VEHICLE RECALL

G-03510-R1 March 2004

SUBJECT: SAFETY RECALL (U.S., EXPORT)

Unitized Wheel Hub on Certain 4000, 8000, and 9000 Series Models Built 1/9/1998 through 3/1/2002 and Certain Service Replacement Unitized Wheel Hubs Installed 5/21/1999 thru 5/2/2000

Figure 1

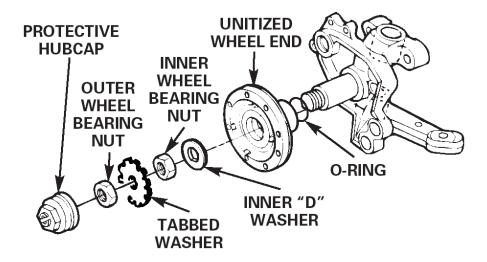
1. Use the correct size socket to remove the threaded protective hubcap from the hub by turning the hubcap COUNTERCLOCKWISE.
